### ROADWAY DESIGN BULLETIN 06-03

**SUBJECT:** Pavement Markings for Exits on Limited Access Facilities

2006 Interim Design Standard

| Index No.<br>17346       |                      |

LAYOUT FOR 1, 2 AND 3 DIGIT NUMBERS AND LETTERS

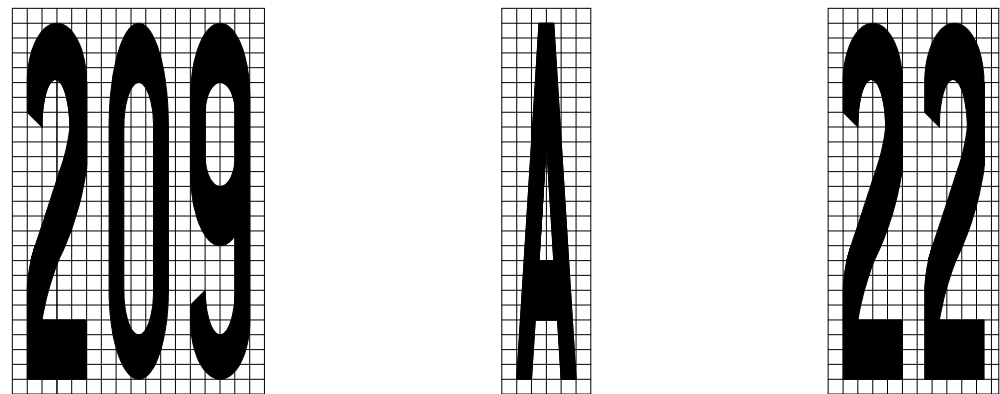
All exits on limited access facilities shall include pavement marking to identify the exit number. The pavement marking shall be located on the shoulder just prior to the exit taper.

The pavement markings shall utilize an 8' letter height and comply with the MUTCD for elongated letters and numbers for word pavement markings. The maximum message width shall be 70" to fit between the rumble strip and the outside edge of the paved shoulder. Since the pavement markings may include two messages, the markings shall read in the direction of travel. The spacing between messages shall be 50'.

The messages shall be white with a contrasting black background. The thickness of the preformed message shall be 125 mils. The black contrasting material shall have a minimum skid resistant value of 55 BPN.
